Taking and Importing Marine Mammals; Taking Marine Mammals
Incidental to the Atlantic Shores Offshore Wind Energy Projects
Offshore of New Jersey

ACTION: Notice; receipt of application for Letters of Authorization;
request for comments and information.

Bob Stern, Ph.D., President
Save Long Beach Island, Inc.

FIG. 1. (Color online) Source SPLs versus nominal wind turbine power as listed in Table 1. The names of wind farms or the data source are indicated at the top of the figure. Regression lines for broadband levels (blue) and sound levels at spectral peaks (red) show the increasing trend.

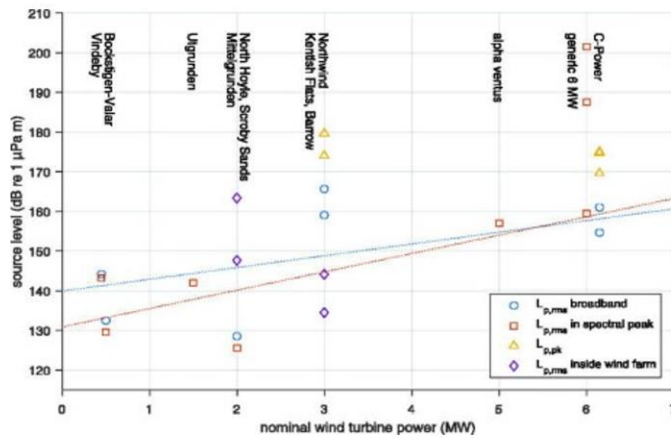
Using the Stober referenced study, **broadband noise source levels for those 13.6 mw gearbox turbines are predicted at 180 dB^{W2}** using the root mean square trend line of Figure 1 of the study below, extrapolated out to 13.6 mw turbines, which is about 40 dB higher and 10,000 times* more intense than the noise from the smaller turbines.

Tougaard Study

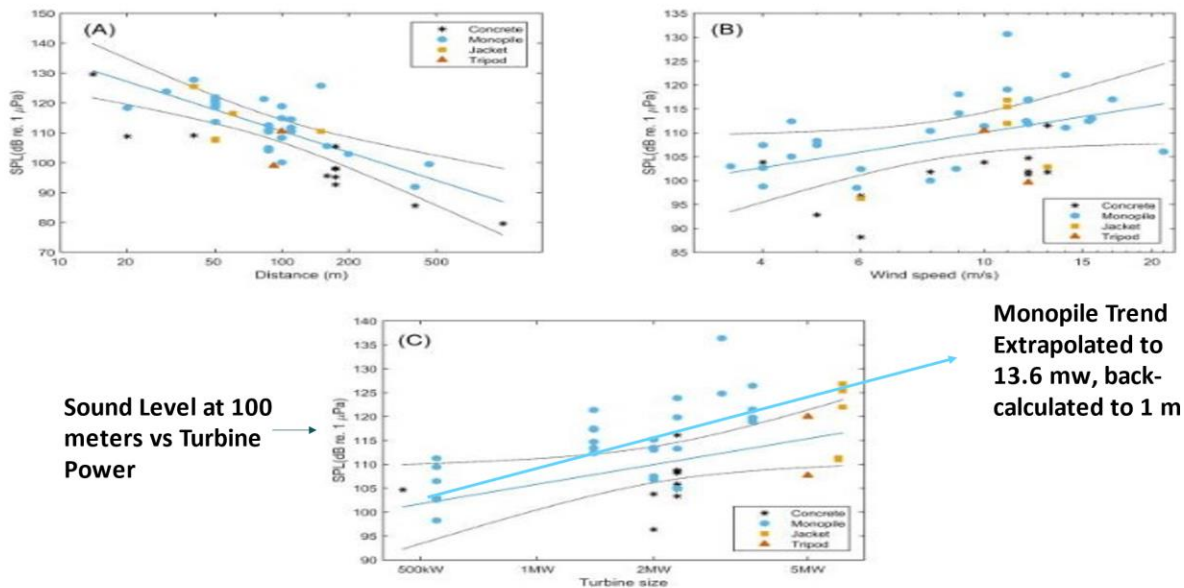
The 180 dB source noise level is confirmed by the second Tougaard study^{W17}. The authors there also tabulated, correlated and plotted broadband sound levels as a function of wind speed, power, and distance. Figure 3(C) below shows the trend in received noise level at 100 meters from the source versus turbine power for monopile foundations. Drawing a trend line through that monopile data and extrapolating it out to 13.6 megawatts results in noise level of 132.5 dB. Back calculating that from 100 meters to the turbine source at 1 meter adds 47.4 dB (page 21) resulting in a **179.9 dB noise source level, consistent with the Stober study.**

In study 1, following author Stober's suggestion, the spectral root means square line is actually a better indicator of the increase in noise level as turbine power increases, because it is more indicative of frequency range that the whale hears. Extrapolating that trend line in his Figure 1 out to 13.6 mw—for the Vesta-236 turbines to be used **results in a turbine noise source level of 192.2 dB**. (We used the more conservative estimate of 180 dB from the broadband trend line in our comments ⁽³⁾ on the NOI because it was sufficient to demonstrate our main point that the 120 dB marine mammal behavior disruption level would be exceeded from shore and through the entire wind turbine complex and the adjacent right whale's migration corridor).

So, the Stober and Tougaard studies are consistent, credible and reliable, and show that we are actually looking at turbine source **operational noise levels between 180 and 192.2 dB**. These source levels should have been used in the ITA application to assess the operational noise impact on the whales.

Exhibit A, North Atlantic Right Whale Population

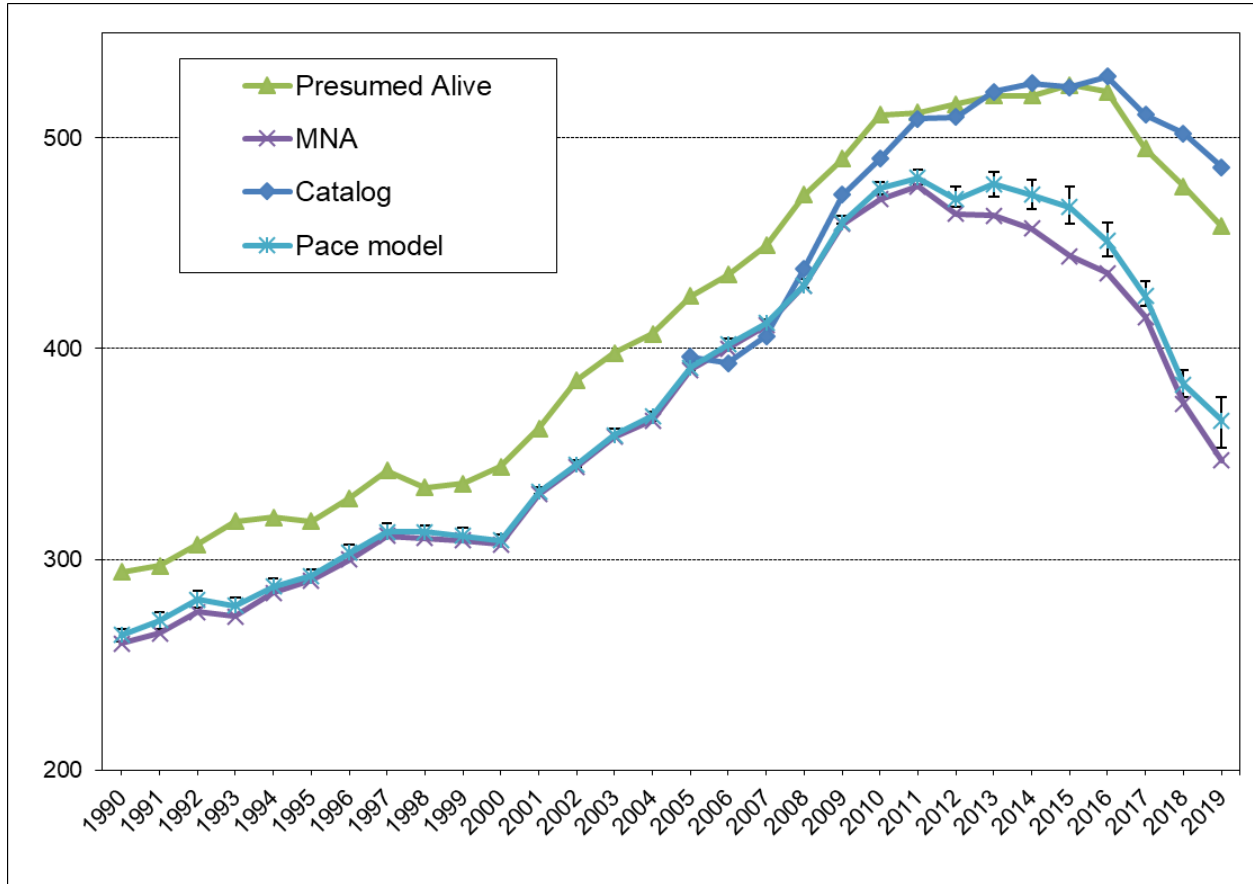
1. The application should clearly show the precarious status of the right whale. The number of critically endangered North Atlantic right whales (NARW) is already low at 366 animals and in steep decline- Exhibit A. There are less than 94 females of reproductive age left.

The numbers of NARW are already very low at 366 animals and in steep decline- Exhibit A. There are less than 94 females of reproductive age left. The NMFS 2020 stock assessment report for the NARW shows an average per female productivity rate of 0.06 for the years 2013 to 2017, Figure 4. It also shows (Figure 2a) an average female population of 180, leading to 11 average births per year. Table 2 shows estimated human caused fatalities at an average of 18.6 per year for that period.

Exhibit B1, North Atlantic right whale migration corridor-Annual Density

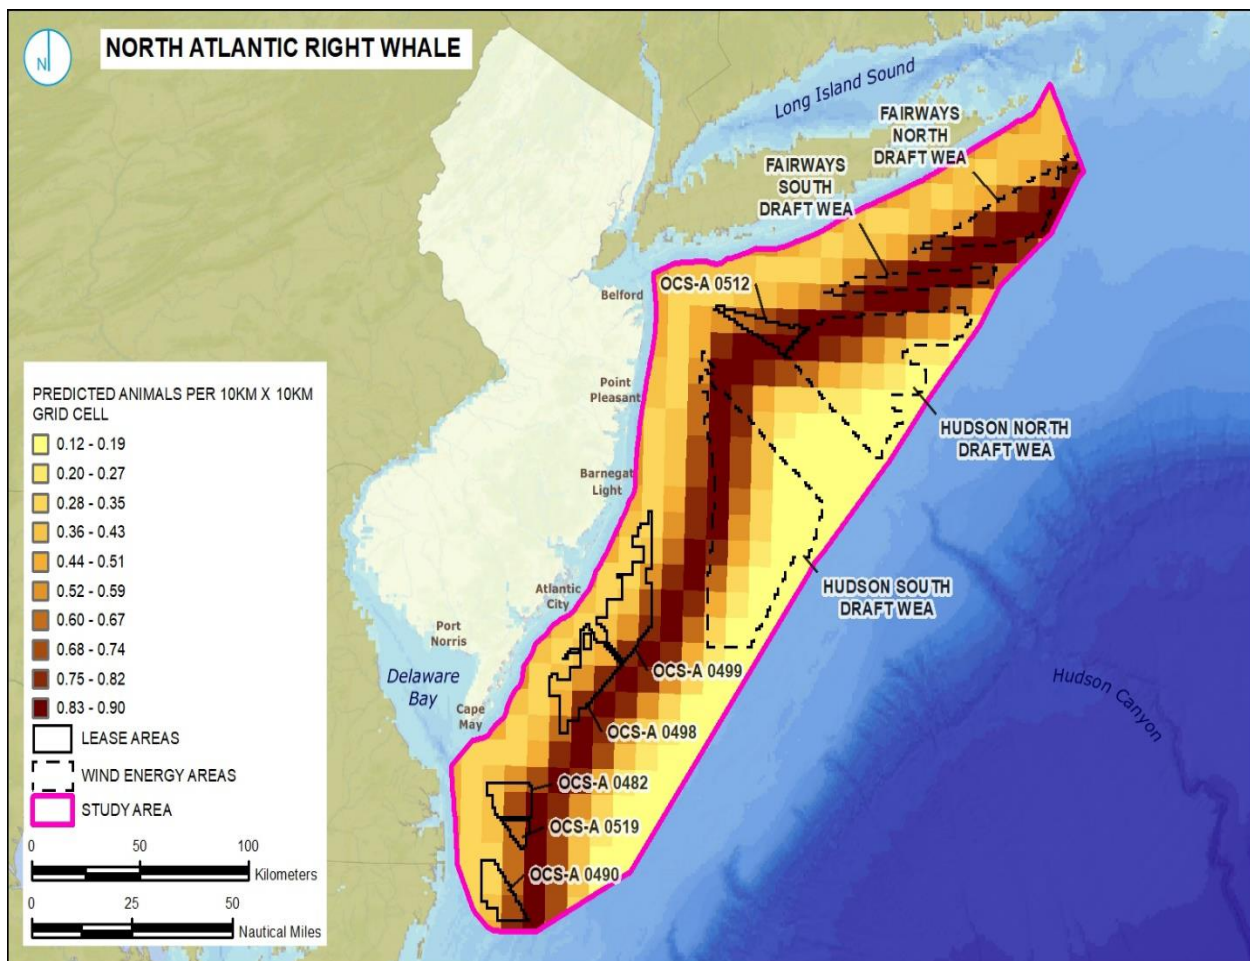
Acknowledgement of the North Atlantic right whale’s Primary Migration Corridor. We are glad to see that Figure 9 of the main application recognizes that the primary migration corridor of the right whale intersects and/or is adjacent to the proposed wind turbine areas (See Exhibits B1, B2, and B3 in Enclosure II).

Exhibit B2, North Atlantic Right Whale Densities

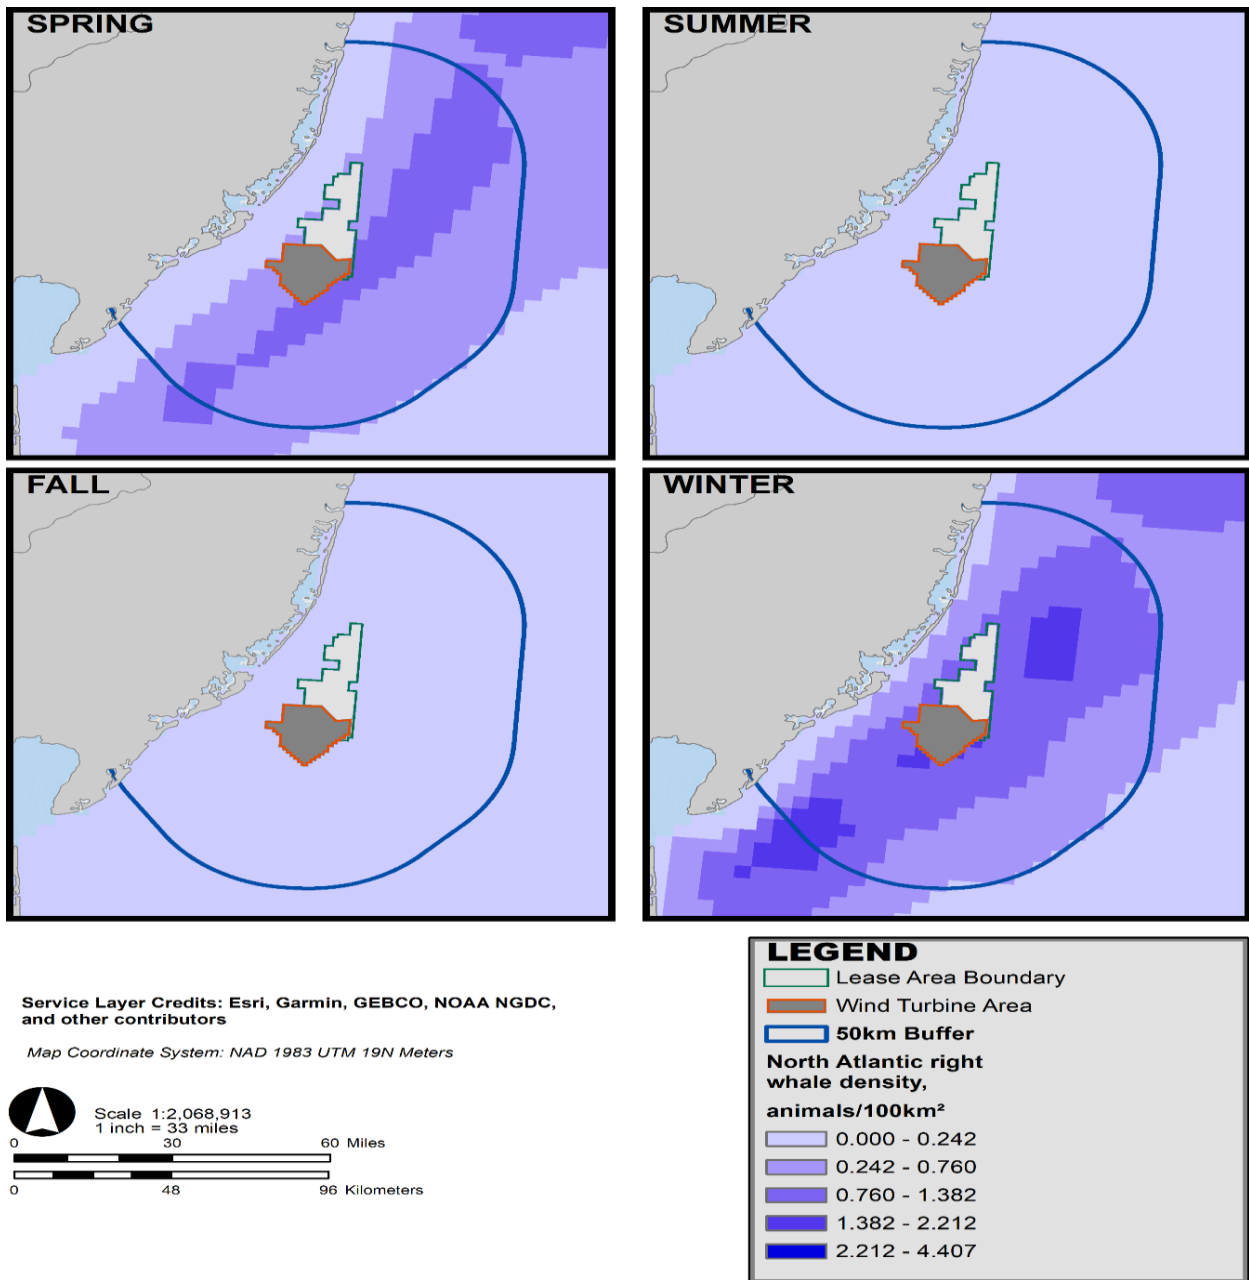
The presence of their primary migratory path is further confirmed by Figure 9 of Atlantic Shores Offshore Wind's own application for an MMPA ITA rulemaking shown in Exhibit B2. The density map there for winter shows that the migration corridor intersects the project area and extends about 12 miles southeast of it. The density map for spring shows an even narrower migration corridor adjacent to the project area of about 5 miles. The presence of the primary corridor is further confirmed in exhibit B3.

Exhibit C, Fin and Humpback Whale Density

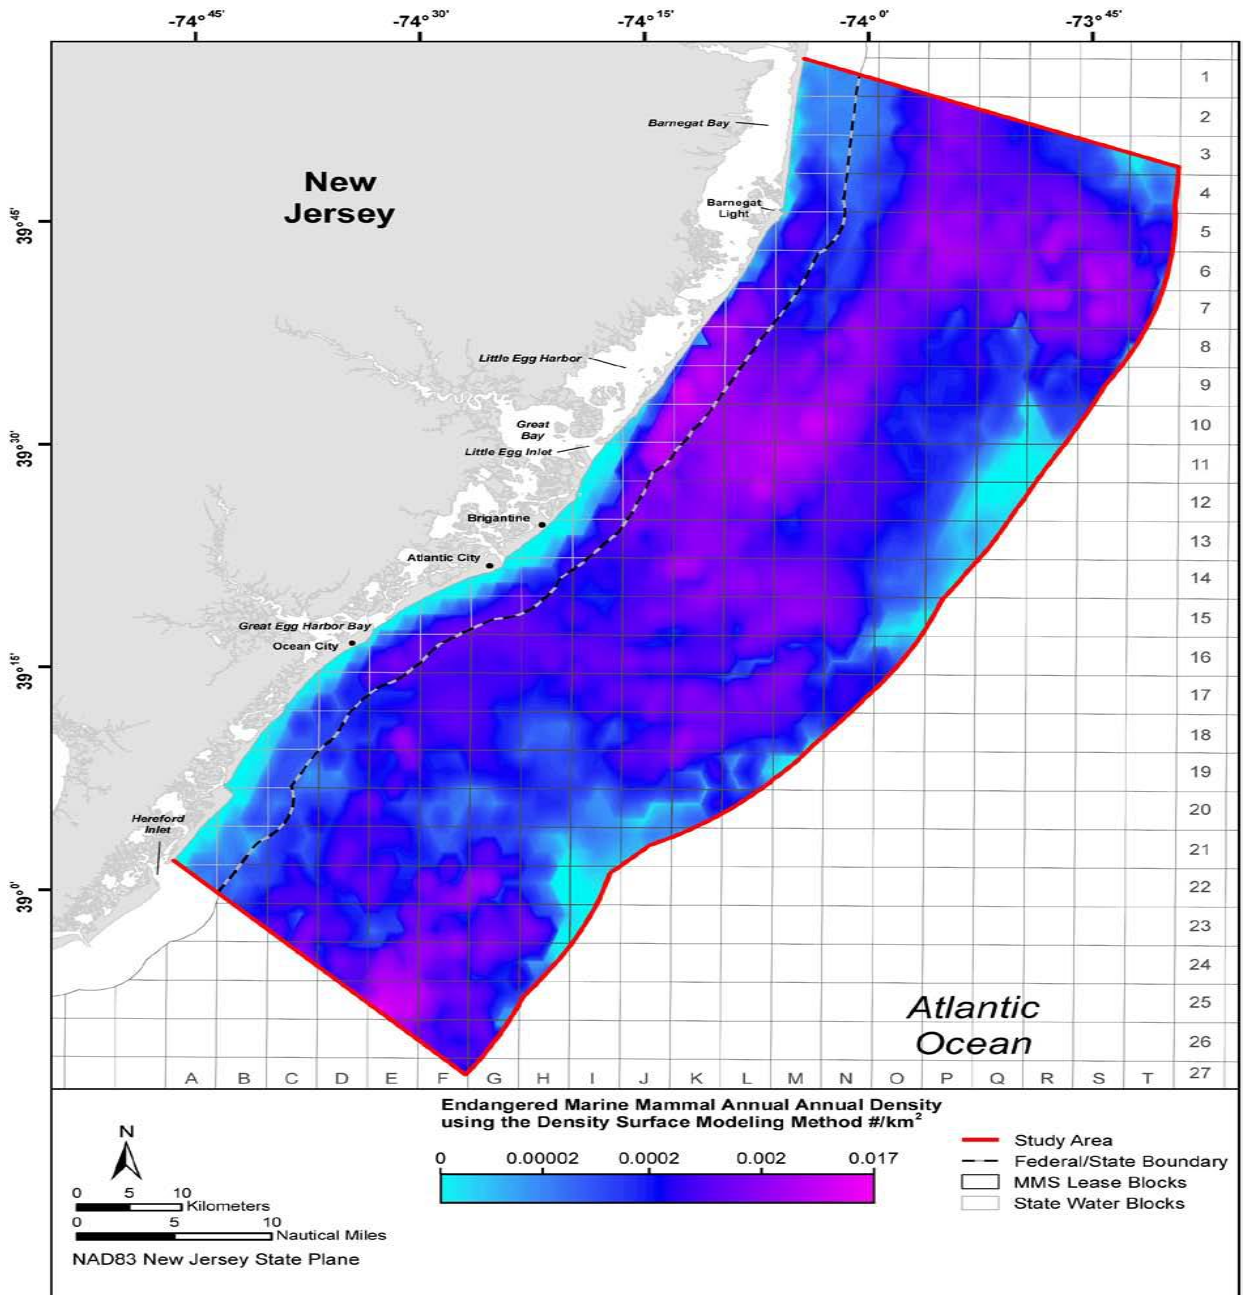
The application should also show that endangered fin and humpback whales frequent the inner part of the project area, distances out to 11.5 miles (Exhibit C).

Exhibit D. Right Whale Migration Density-Annual Basis

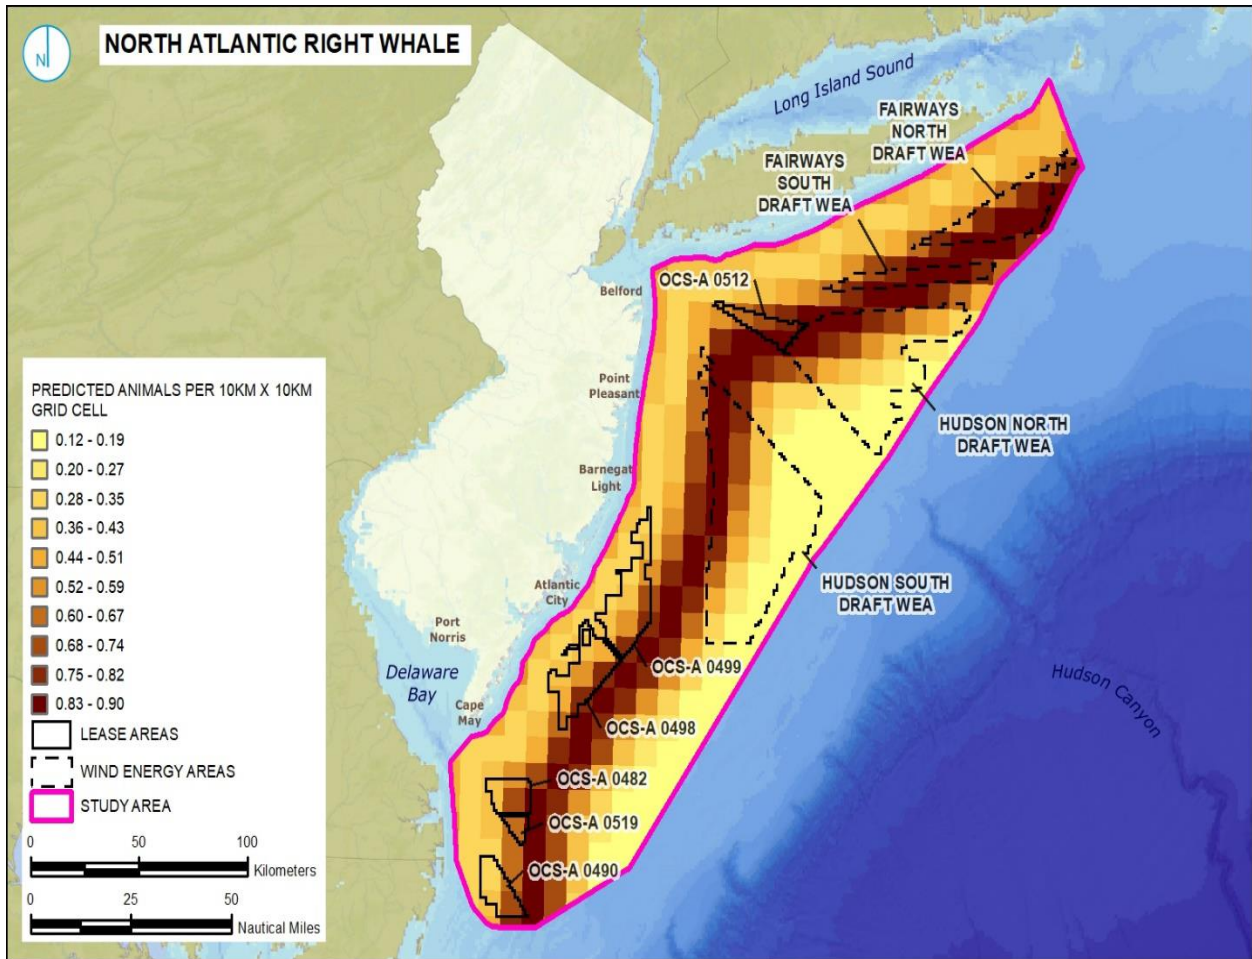
The concentration of the right whale's migration near and within the survey area is shown in Exhibit D here on an annual basis and in Exhibit E for the month of March. The presence of their primary migratory path is further confirmed by Figure 9 of Atlantic Shores Offshore Wind own application for an MMPA ITA rulemaking shown in Exhibit G. The density map there for winter shows that the migration corridor intersects the project area and extends about 12 miles southeast of it. The density map for spring shows an even narrower migration corridor adjacent to the project area of about 5 miles.

Exhibit F. North Atlantic Right Whale Population Trend

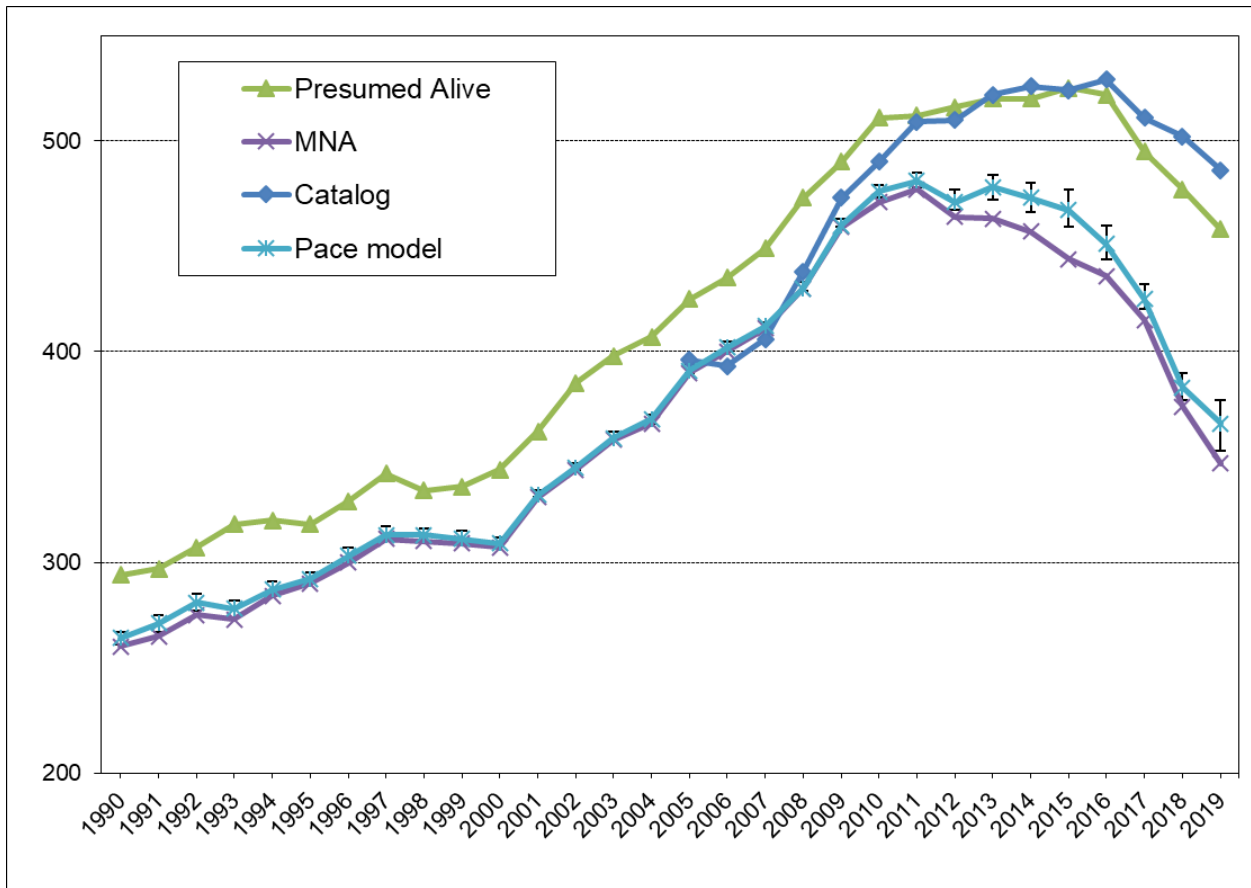
The numbers of North Atlantic right whales are already very low at 350 animals and in steep decline (see Exhibit F). There are less than 94 females of reproductive age left. The NMFS 2020 stock assessment report for the North Atlantic right whale in Figure 4 shows an average per female productivity rate of 0.06 for the years 2013 to 2017. It also shows in Figure 2a an average female population of 180, leading to 11 average births per year. Table 2 of that report shows estimated human-caused fatalities at an average of 18.6 per year for that period.
